AMENDMENT OF SOLICITATION/MODIFICATION OF CONTRACT			1. CONTRACT ID CODE	PAGE OF PAGES	
			J	1	9
2. AMENDMENT/MODIFICATION NO. 0004	3. EFFECTIVE DATE 12-Oct-2005	4. REQUISITION/PURCHASE REQ. NO.		5. PROJECT NO.(If applicable) Dalmado

14. DESCRIPTION OF AMENDMENT/MODIFICATION (Organized by UCF section headings, including solicitation/contract subject matter where feasible.) The above numbered solicitation for Chalmette Area Plan Emergency Restoration, MRGO B/L Station 714+55 to 1007+91, Hurricane Protection Levee, St. Bernard Parish, LA is amended as follows: <ol style="list-style-type: none"> <li>Section 02318 para 3.1.2.1. Delete words "compacted" &amp; replace with "semicompacted". (see attached)</li> <li>Revised bid schedule, section 00010 (see attached)</li> <li>Revised Plan &amp; Profile &amp; Typical Design section drawings (see attached)</li> <li>Closing Date: PROPOSALS ARE DUE 13 OCT 2005 AT 1:00 PM LOCAL TIME.</li> </ol>					
Except as provided herein, all terms and conditions of the document referenced in Item 9A or 10A, as heretofore changed, remains unchanged and in full force and effect.					
15A. NAME AND TITLE OF SIGNER (Type or print)			16A. NAME AND TITLE OF CONTR

LAKE PONTCHARTRAIN AND VICINITY  
 CHALMETTE AREA PLAN EMERGENCY RESTORATION  
**LEVEE RESTORATION EAST OF BAYOU DUPRE**  
 MRGO B/L STA. 714+55 TO STA. 1007+91  
 PLAN AND PROFILE  
 ST. BERNARD PARISH, LA

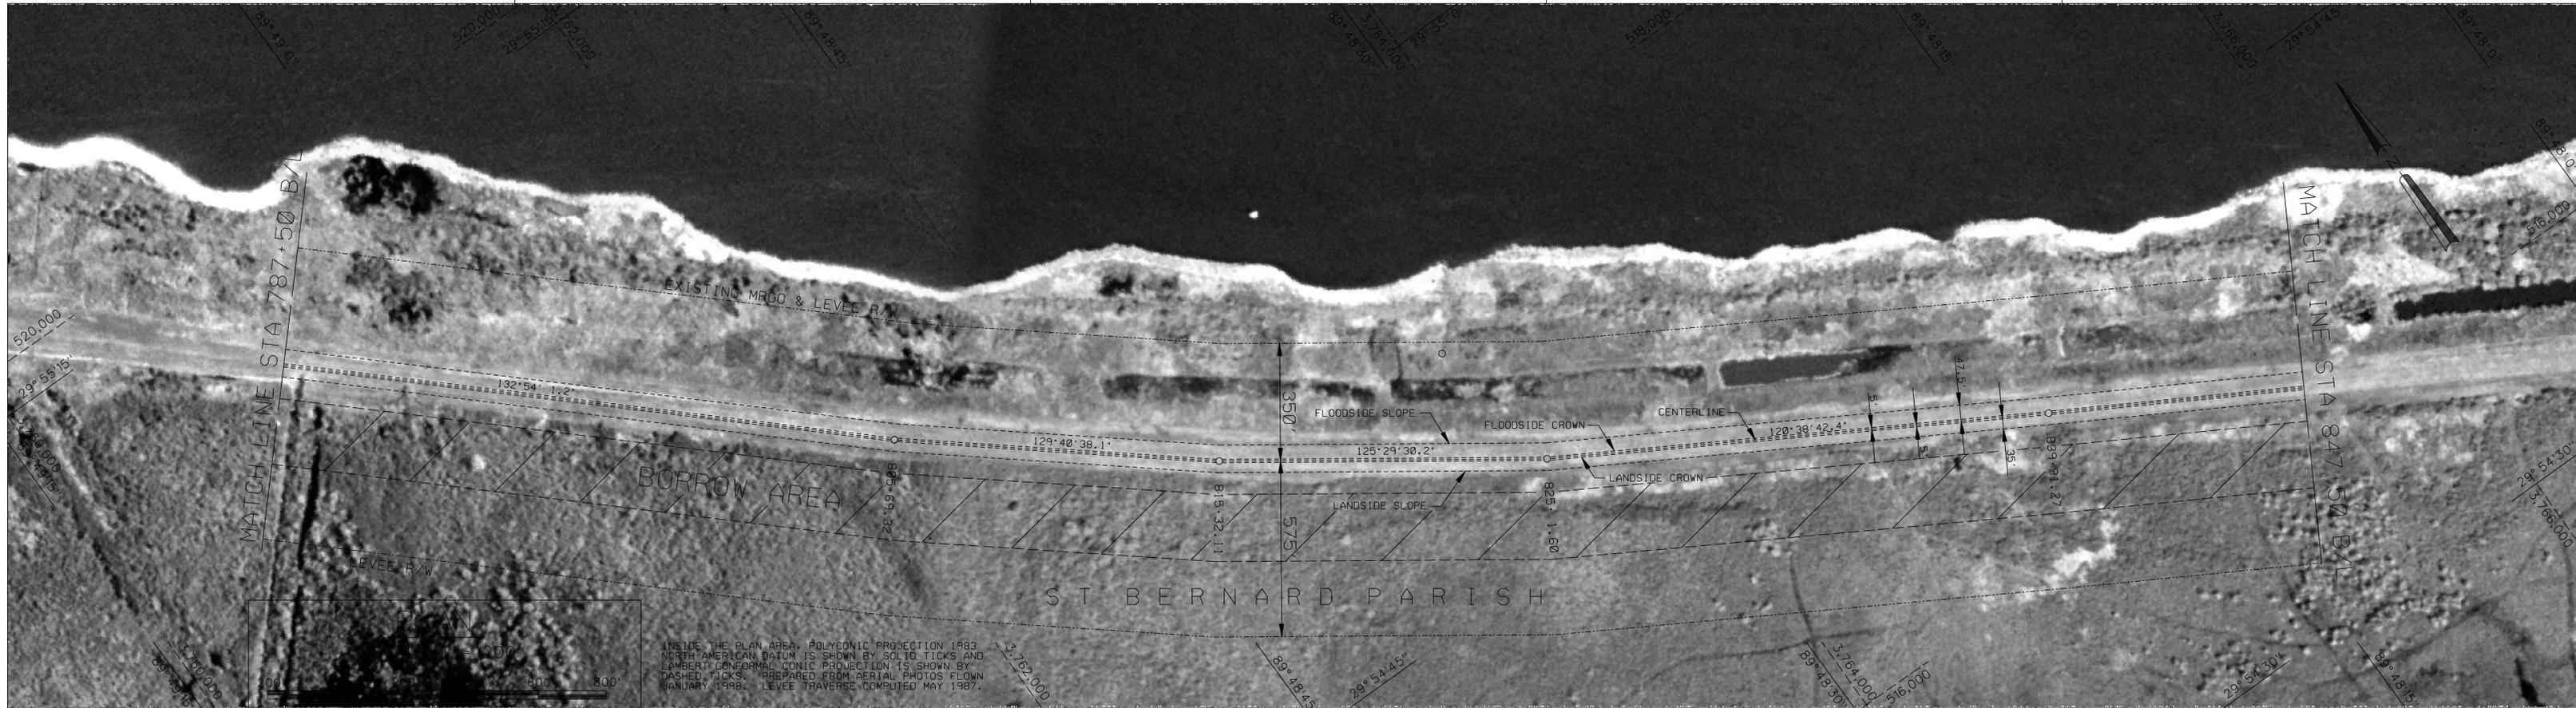
REV.	AMENDMENT NO.	DESCRIPTION	BY	DATE	APP'D.
1		CHANGED DESIGN SECTION	S.O.J.	10/11/05

LAKE PONTCHARTRAIN AND VICINITY  
 CHALMETTE AREA PLAN EMERGENCY RESTORATION  
**LEVEE RESTORATION EAST OF BAYOU DUPRE**  
 MRGO B/L STA. 714+55 TO STA. 1007+91  
 PLAN AND PROFILE  
 ST. BERNARD PARISH, LA  
 U.S. ARMY ENGINEER DISTRICT, NEW ORLEANS  
 CORPS OF ENGINEERS  
 NEW ORLEANS, LOUISIANA

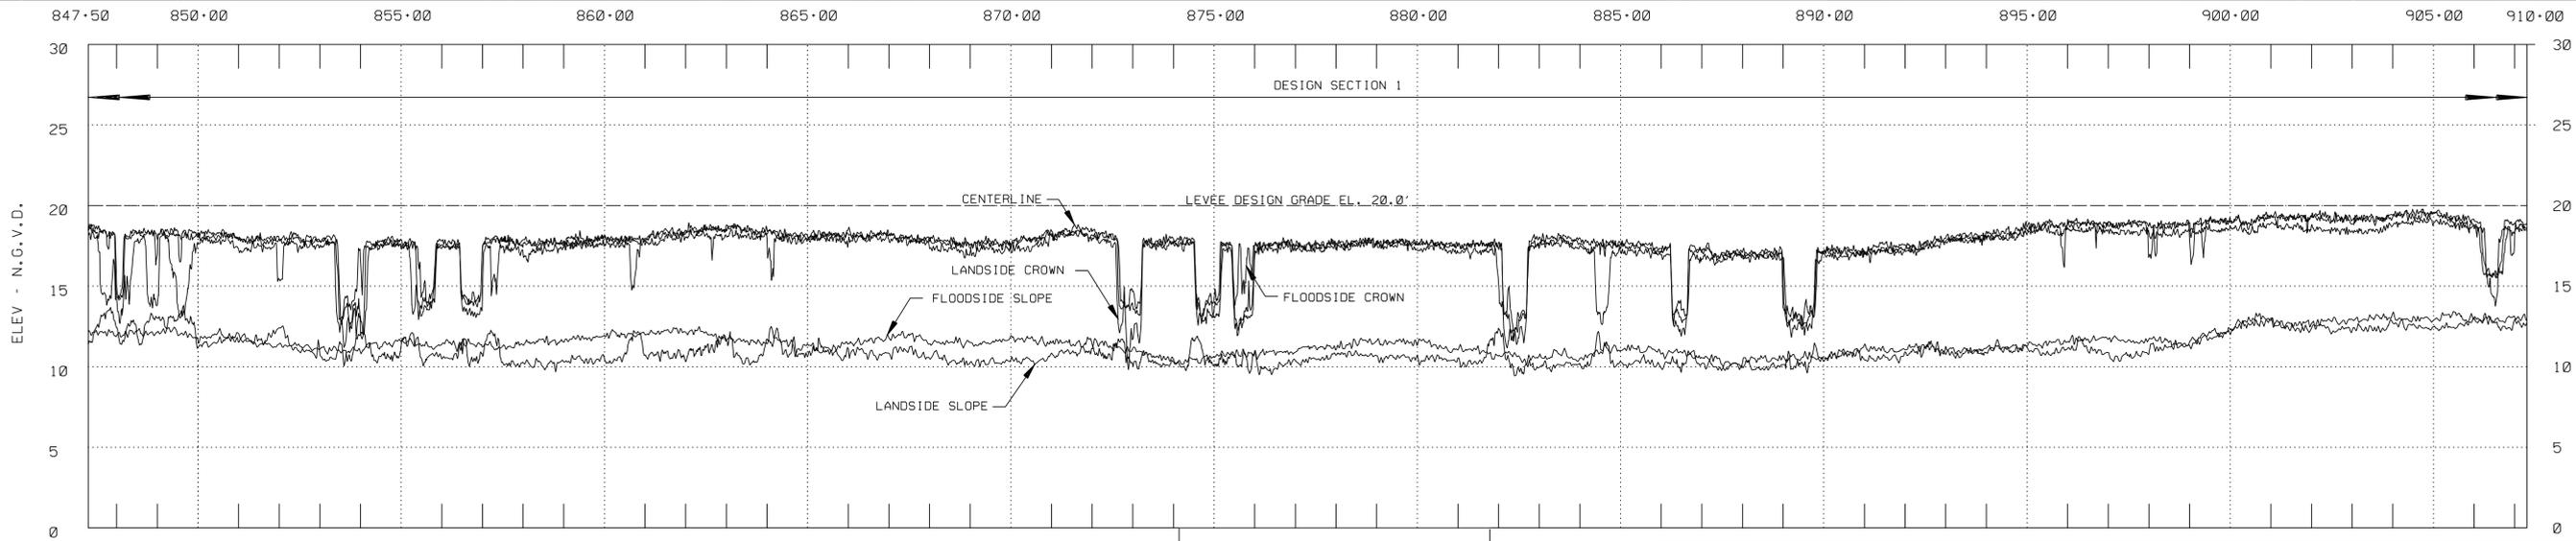
REV.	AMENDMENT NO.	DESCRIPTION	BY	DATE	APP'D.
1		CHANGED DESIGN SECTION	S.O.J.	10/11/05

**LEVEE RESTORATION EAST OF BAYOU DUPRE**  
MRGO B/L STA. 714+55 TO STA. 1007+91

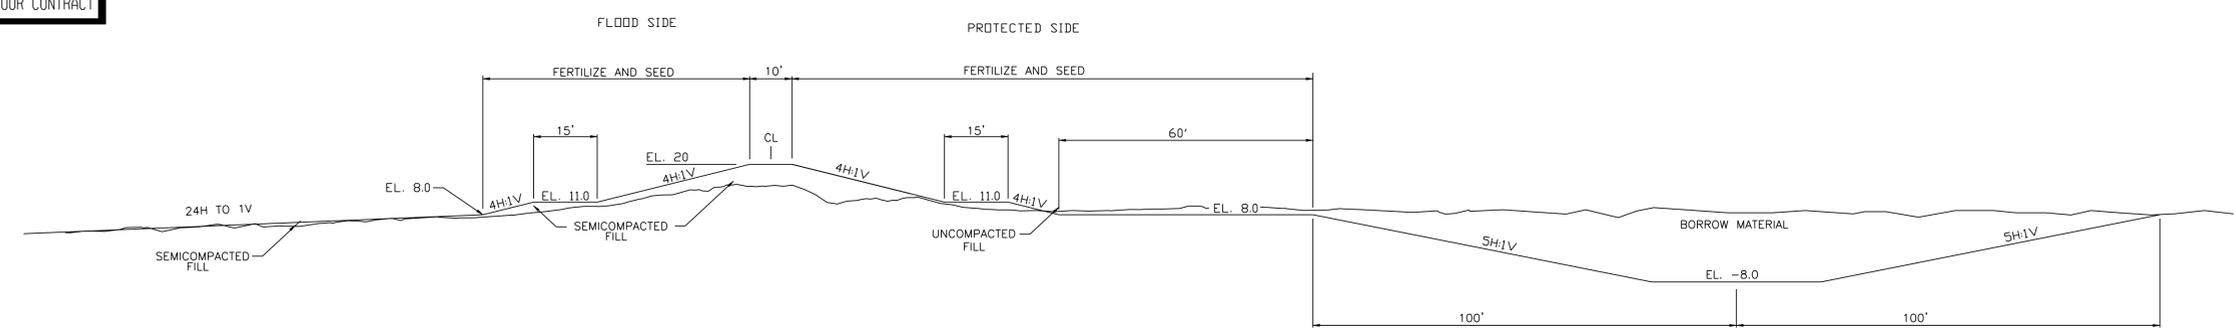
REV.	AMENDMENT NO.	DESCRIPTION	BY	DATE	APP'D.
1		CHANGED DESIGN SECTION	S.O.J.	10/11/05

LAKE PONTCHARTRAIN AND VICINITY  
 CHALMETTE AREA PLAN EMERGENCY RESTORATION  
**LEVEE RESTORATION EAST OF BAYOU DUPRE**  
 MRGO B/L STA. 714+55 TO STA. 1007+91  
 TYPICAL DESIGN SECTIONS  
 ST. BERNARD PARISH, LA

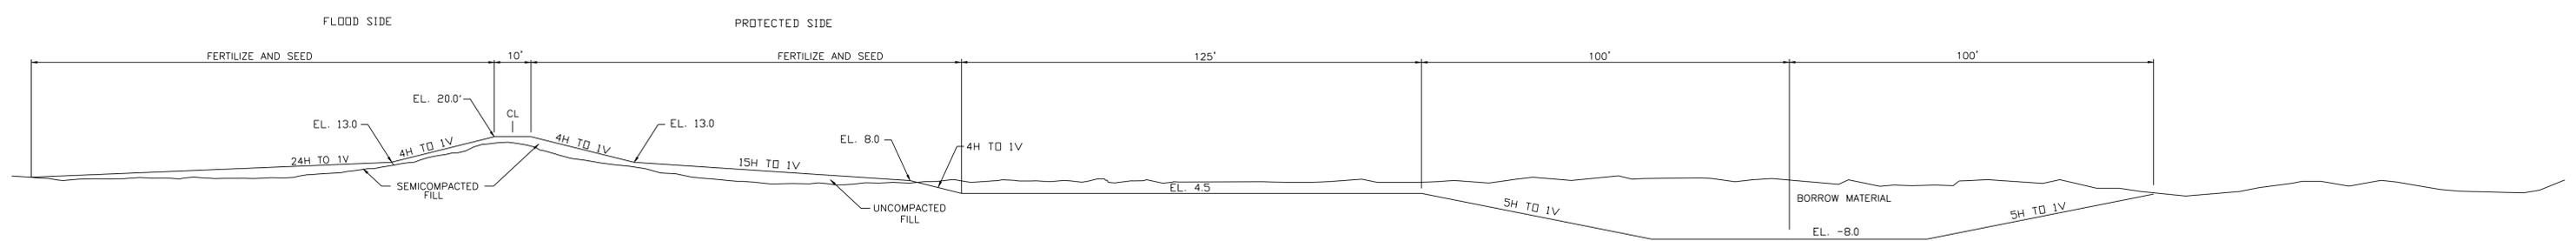
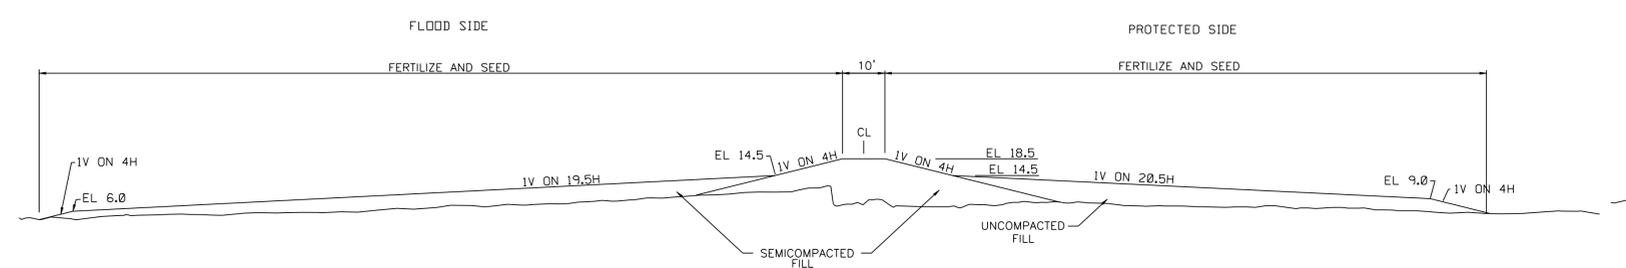
REV.	AMENDMENT NO.	DESCRIPTION	BY	DATE	APP'D.
1		GENERAL REVISION	S.O.J.	10/11/05
